Service Manual Supplement Trucks

This Service Bulletin is a supplement to Service Manual, Group 86, Front Bumper, VNL, VNM, PV776-TSP103726/1.

Front Bumper VNL, VNM

Installing Grote Drive and Fog Lamps on the **SMC Bumper**

W8002295

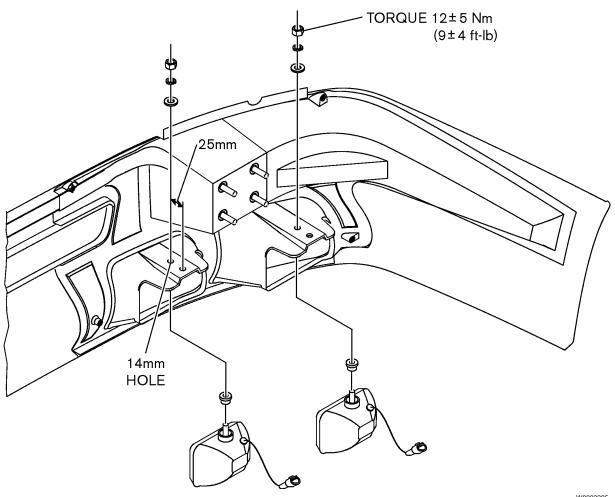
In October 1998, a new SMC bumper for the VN Series went into production . This new bumper is designed to mount Unity brand drive and fog lamps. Before production of the new design, Grote brand drive and fog lamps were used.

The previous bumper design is not available as a replacement part. However, if the bumper is replaced and Grote lamps are to be used on the new bumper, the bumper must be modified.

For each Grote lamp to be used, drill an additional mounting hole 25 mm (1 in.) forward of the existing mounting hole. The new mounting hole size is 14 mm (0.55 in.). Torque the lamp mounting bolt to 12 ± 5 (9 ± 4 ft-lb).
